TRANSMITTAL AND RESPONSE TO COMMENTS FOR RCRA FACILITY INVESTIGATION
REPORT ADDENDUM AREA OF CONCERN 723 (AOC 723) ZONE E CNC CHARLESTON SC

ROC 723 Zone E
RtC on RFA/RFL Report Addendums

Re: CH2M-Jones' Responses to Comments by SCDHEC regarding the *RFA/RFI Report Addendum, AOC 723, Zone E, Revision 0* – Originally Submitted on May 9, 2003

Figur 3-3
Locations of Proposed and Existing Monitoring Wells
AOC 723 Area, Zone E
Charleston Naval Complex

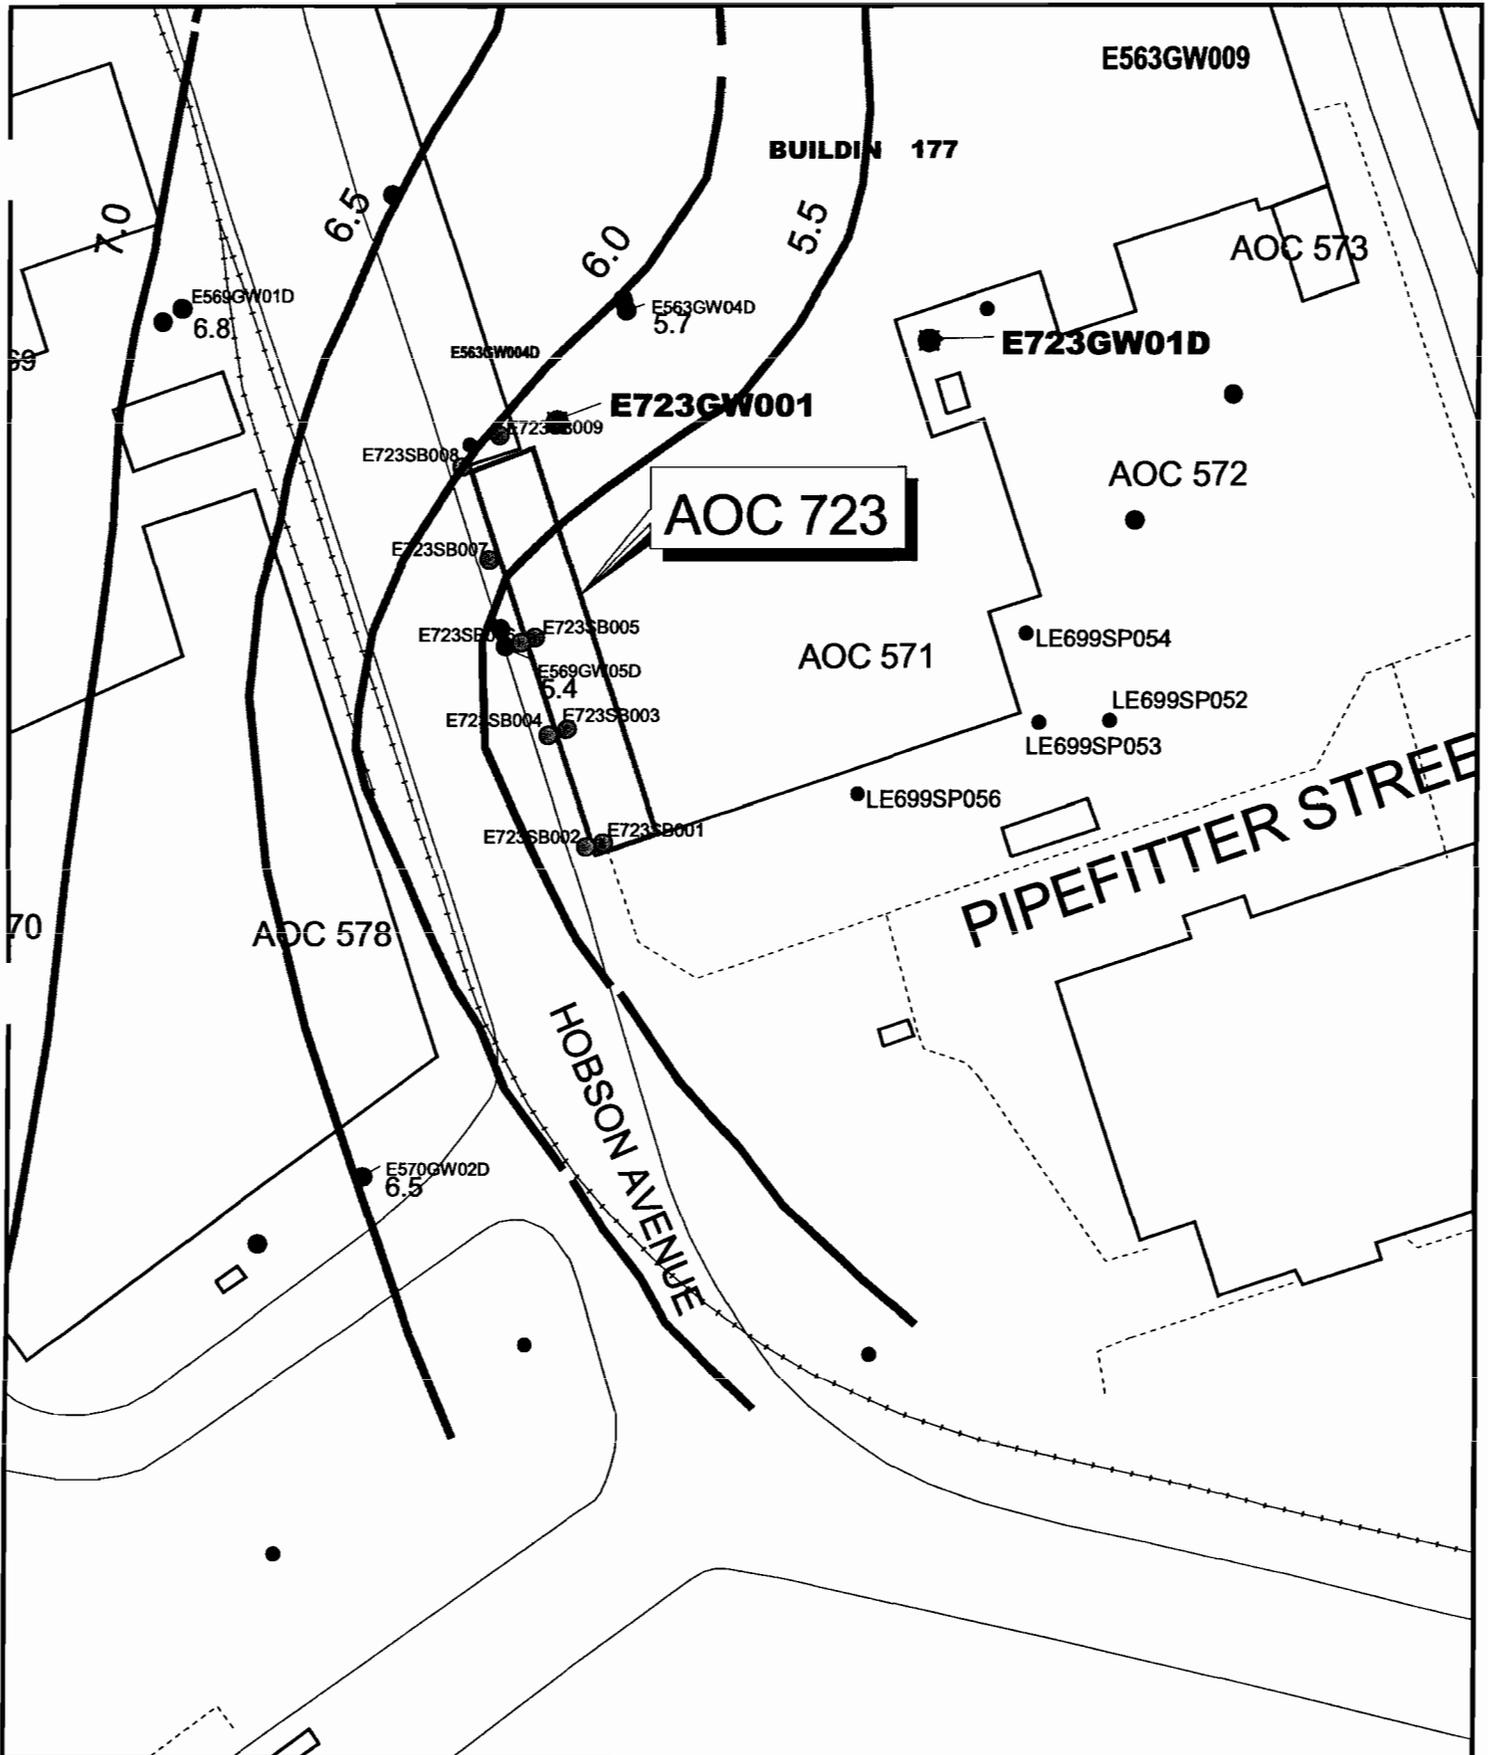
- Replace the Workplan Figure 3-3 entitled *Locations of Proposed and Existing Monitoring Wells* with facsimiled Figure 1 entitled *Zone L DPT Borings near Bldg 177 and Revised Deep Well Location, for AOC 723.*

-
- The Navy must install the shallow monitoring well E723GW001 and deep monitoring well E723GW01D in the locations depicted on facsimiled Figure 1.

Replacement Figure 3-3 is attached.

These wells have been installed at these locations during September 2003.
